# LAWRENCEVILLE

## **PLANNING COMMISSION**

### **MEETING MINUTES**

#### RZR2024-00022 & SUP2024-00090

SHEET TITLE  
CONCEPT SITE PLAN  
SHEET NUMBER  
1.0

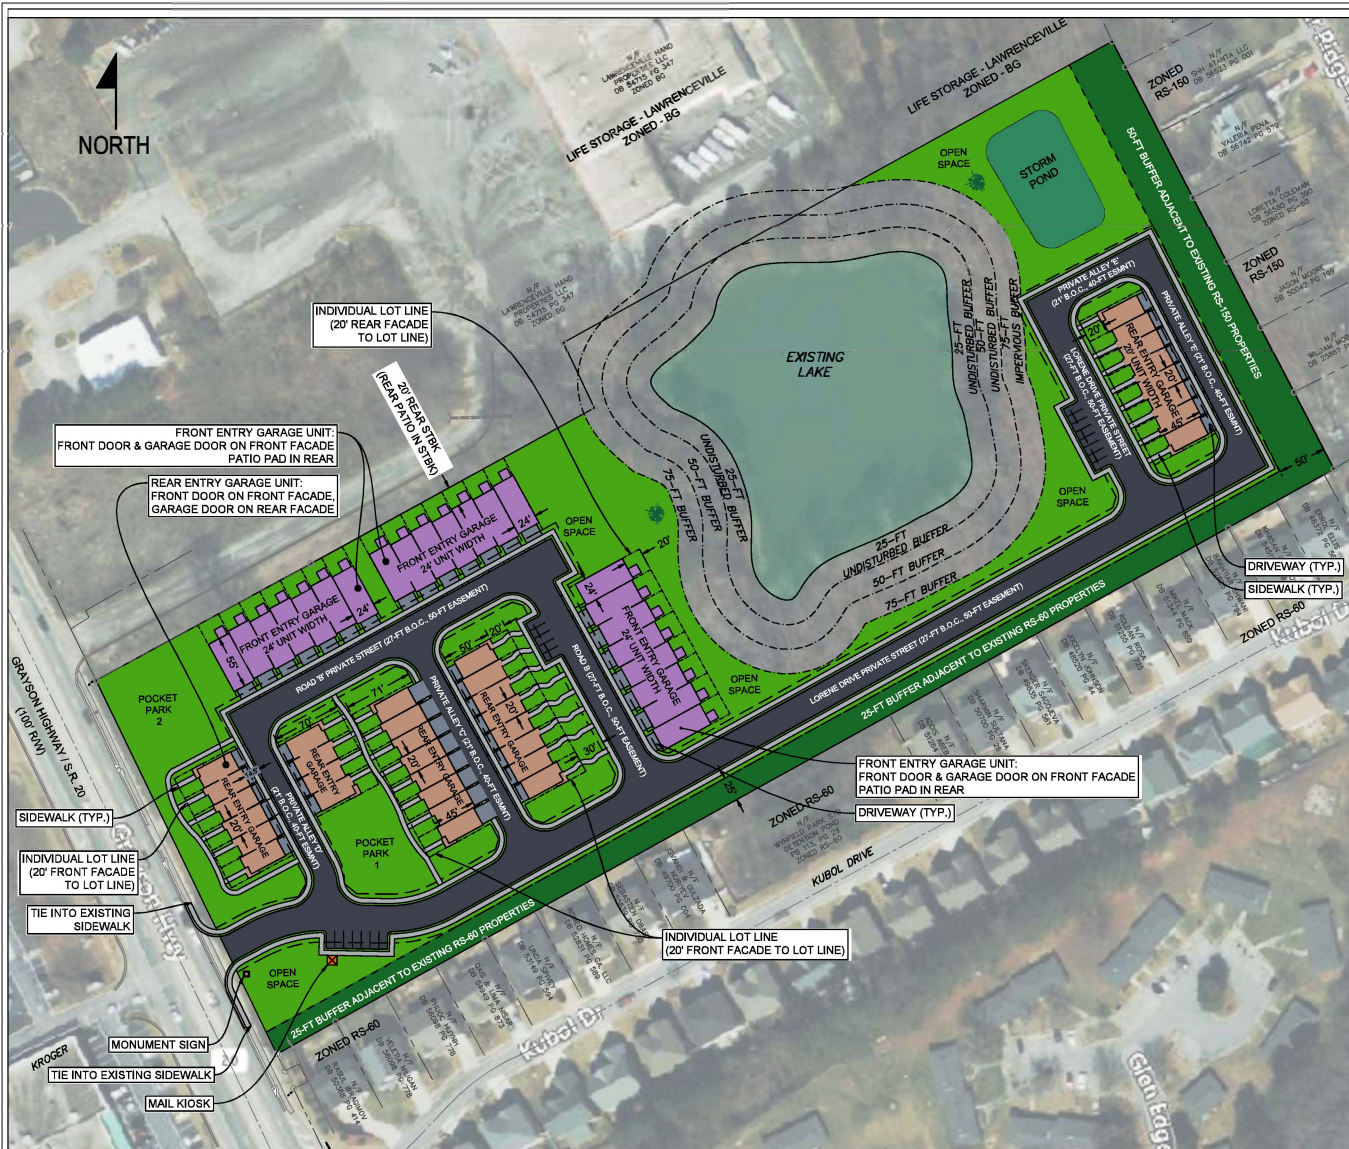
- Requested an increase in buffers adjacent to Wynfield Park subdivision;
- Requested removal of invasive plant species, noxious weeds, etc. encroaching onto properties adjacent to Wynfield Park subdivision;
- Requested preservation of habitat for natural resources (wildlife);
- Condition E. – five-foot (5 ft.) Front Yard Setback adjacent to Road ‘B’ Private Street;
- Condition H. – driveway depth (8 ft.) and width (16 ft.);
- Variance E.7. - curb-cut depth (8 ft.) and width (16 ft.); and five-foot (5 ft.) Rear Yard Setback adjacent to proposed forty-foot (40ft.) Utility Access Easement.

- A. A variance from the Zoning Ordinance, Article 1 Districts, Section 102.7 RM-24 Multifamily Residential District, Subsection B., Lot Development Standards. Allows for the reduction of the fifty (50) feet undisturbed stream buffer.
- B. A variance from the Zoning Ordinance, Article 1 Districts, Section 102.7 RM-24 Multifamily Residential District, Subsection B., Lot Development Standards. Allows for the reduction of the seventy-five (75) foot impervious stream buffer.
- C. Variance to allow a Private Alley in lieu of the required Private Drive as follows: E. 4. a. Private Alley 'C', 'D' and 'E' street width shall be twenty-one foot (21 ft.). Two foot curb and gutter required (dimensions are back to back

D. Variance to allow the elimination of the five foot (5 ft.) sidewalk requirement adjacent to Private Alley 'C', 'D' and 'E' b. - A 5-foot sidewalk is required and shall be 2 feet off the back of curb.

E. Variance to allow Driveway within the required forty foot (40 ft.) Private Alley Utility Easement must provide two external parking spaces (9 ft. x 20 ft. each) providing a curb cut measuring eight feet (8 ft.) in depth and sixteen feet (16 ft.) in width.

~~B.F.~~ Variance to allow the rear elevations (including porches, decks, etc.) of Rear Entry Units shall be setback 27 feet five foot (5 ft.) rear yard setback from the required forty foot (40 ft.) Utility Access Easement.
